**RESPONSE LETTER NO. 5 TO REQUEST FOR INFORMATION**

Project Title: **Roadway Improvements to NE 151 Street from East of Railroad Tracks to Bay Vista Boulevard**

Project No.: **20210092 (Capital)**

**RFI from Ms. Hamill Andrade, Ric-Man International, Inc; dated September 23, 2022. (attached)**

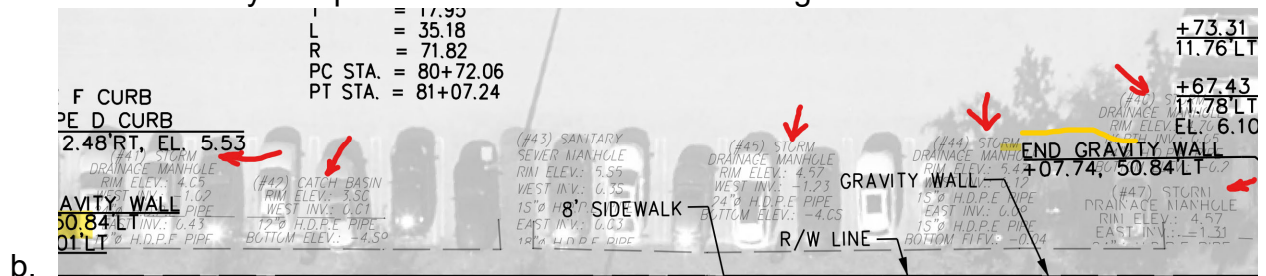
**QUESTION:** 2) Plan Sheet #15 Shows 10 SW corner of Biscayne and 151 st, shows a dash line going across Biscayne Blvd and stopping before the median. Is this pipe and the other pipes and structures to the west intended to be removed. There is no call-out requiring it to remain?

- 29) Plan Sheet #15 Shows 10 SW corner of Biscayne and 151 st, shows a dash line going across Biscayne Blvd and stopping before the median. Is this pipe and the other pipes and structures to the west intended to be removed. There is no call-out requiring it to remain?

**RESPONSE:** 2) The scope of work within those limits is Milling and Resurfacing as stated in the plans and the typical sections
